# HILLSBOROUGH COUNTY BOCC LAND USE MEETING AGENDA July 09, 2024 CHANGES/CORRECTIONS/ADDITIONS

**PD Modification Application:** PRS 24-0301

APPLICATION NUMBER:	PRS 24-0301	
ZHM HEARING DATE:	N/A	
BOCC LUM MEETING DATE:	July 9, 2024	Case Reviewer: Michelle Heinrich, AICP

# 3.0 TRANSPORTATION SUMMARY (FULL TRANSPORTATION REPORT IN SECTION 9 OF STAFF REPORT)

2.4 Proposed Site Plan (partial provided below for size and orientation purposes. See Section 8.2 for full site plan)

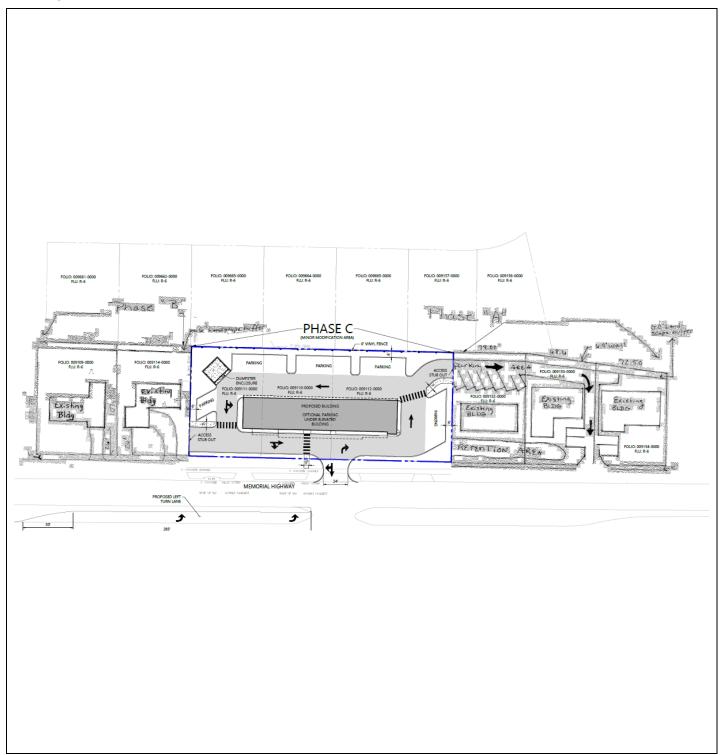
The area of modification is centrally located within the subject Planned Development. No additional uses or square footage beyond what was previously approved is requested. The maximum number of buildings on the site will decreate. Access changes are limited to Memorial Highway, which is reduced from six to four and access point to the northern residential is proposed. Cross access among the three phases will improve on-site circulation and Memorial Highway access.

The maximum height of the one central building within Phase C is proposed to be measured from the design flood elevation (DFE), rather than the base flood elevation (BFE) due to the building's construction using freeboard. Freeboard is elevating the building lowest floor above predicted flood elevations by typically 1 to 3 feet. This will increase the overall height of a structure. The site is located in the Coastal High Hazard Area.

Current conditions require a 6 foot high wall and landscaping, consisting of landscaping and 8 foot tall trees along the northern PD boundary. The applicants request to provide the option of a six foot high vinyl fence in lieu of the wall, and 10 foot tall trees in lieu of 8 foot tall trees within Parcel C. In contract to the existing screening option, this proposed screening option would be an acceptable Type B screening option under the current Land Development Code. It should also be noted that under the proposed layout, the building within Parcel C will be located further from the northern PD boundary than required under the original plan. The aera adjacent to the northern boundary will be used for parking and a one-way drive aisle for Phases C and A. Phase B, which was previously to be unified with Phase A's parking and drive aisle, limited to southern area of the site, decreasing the activity along the northern boundary. Staff is supportive of the request.

Supported, subject to proposed conditions of approval.

# 7.0 ADDITIONAL INFORMATION AND/OR GRAPHICS

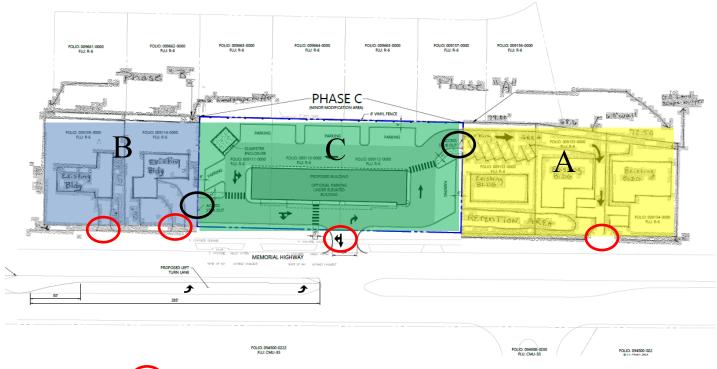
The proposed modification seeks to consolidate three (3) of these connections into a single connection serving newly created Phase C. This will align with the existing median opening, which is the subject of the access spacing request further described hereinbelow. The applicant is proposing to construct an eastbound to northbound left turn lane together with the initial increment of redevelopment within Phase C. The developer is also being required to close the median located immediately west of the project at that time.

The final configuration of the project necessitates all driveways within Phase C be considered Shared Access Facilities, as they will provide the only legal means of ingress to remaining lands within Parcel A once the ultimate configuration mentioned above is triggered. This represents an existing condition with the existing approved PD, although the applicant is proposing to modify internal circulation patterns.

Staff has also had the applicant provide a stubout to the western project boundary, as it is anticipated that if the Phase B properties come in for a zoning modification they will be required to use the single access within Phase C (staff notes the current arrangement within Phase B does not meet Sec. 6.04.03.I requirements governing number of access connections nor Sec. 6.04.07 requirements governing access spacing, and is not a proper design or arrangement for an arterial roadway). Staff is unable to effectuate this change as a part of this application, since Phase B is not a part of the modification area.

# 8.2 Proposed Site Plan (Full)

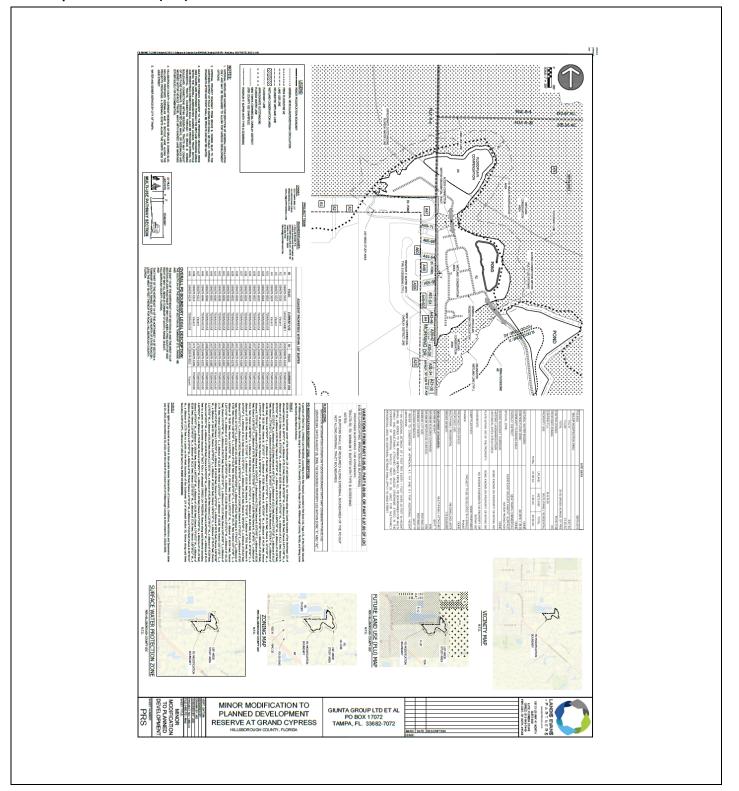
1. Correct PD size from 2.99 to 1.5 acres.

Approval of the request, subject to the conditions listed, is based on the revised general site plan submitted June 20, 2024.

PD1.0

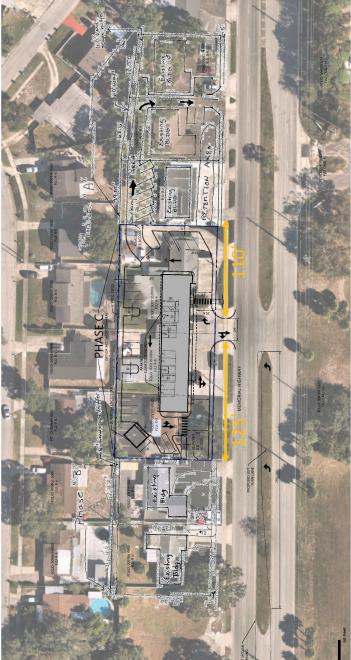
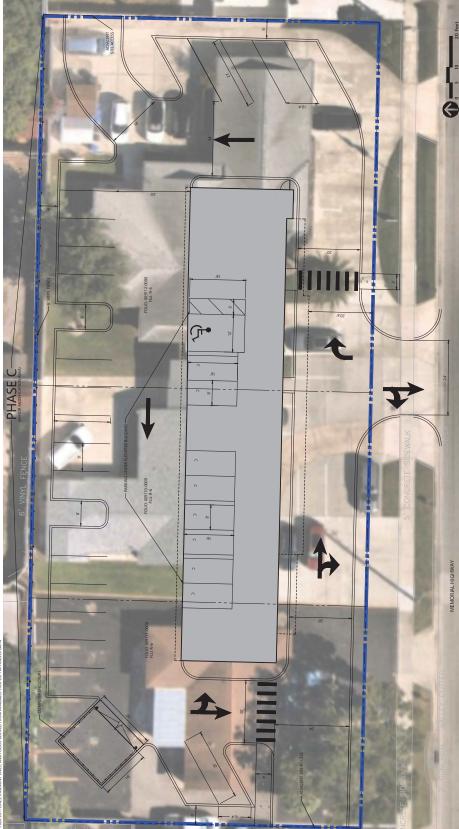
The proposed access is approximately 110 feet from the western driveway serving 5109 Memorial Highway and approximately 125 feet from the driveway serving 5117 Memorial Highway, as shown in Figure 2. Furthermore, the immediate median opening to the west is proposed to be closed with the development of the project.

This request is to provide one (1) driveway on Memorial Highway and remove two (2) additional driveways on Memorial. The existing driveway is proposed to maintain the alignment with the median opening. Additionally, cross access to the parcels to the east are proposed to be maintained in the PD. To the west is a parcel with a single means of access. However, as part of this modification, a future shared access connection will be provided to the parcel so in the event of redevelopment the access spacing to the west could be increased to

The project driveway is proposed to align with the existing median opening on Memorial Highway. In conjunction with the redevelopment of the property, an eastbound left turn lane on Memorial Highway into the project will be provided. Furthermore, the existing median opening immediately to the east will be closed, which will remove a median opening that does not meet spacing standards and does not have a left turn lane. In addition to the median modifications, the project proposes to provide one (1) driveway on Memorial Highway and remove two (2) additional existing driveways on Memorial Highway. With these modifications this driveway spacing would not be detrimental to the public health, safety and welfare of the motoring public.

If PRS 24-0301 is approved by the BOCC, the County Engineer will approve the above-described Administrative Variance. This variance applies only to development within Phase C.

Vicki/Michael - I have found the attached Section 6.04.02.B. Administrative Variance (AV) for PD 24-0301 APPROVABLE.
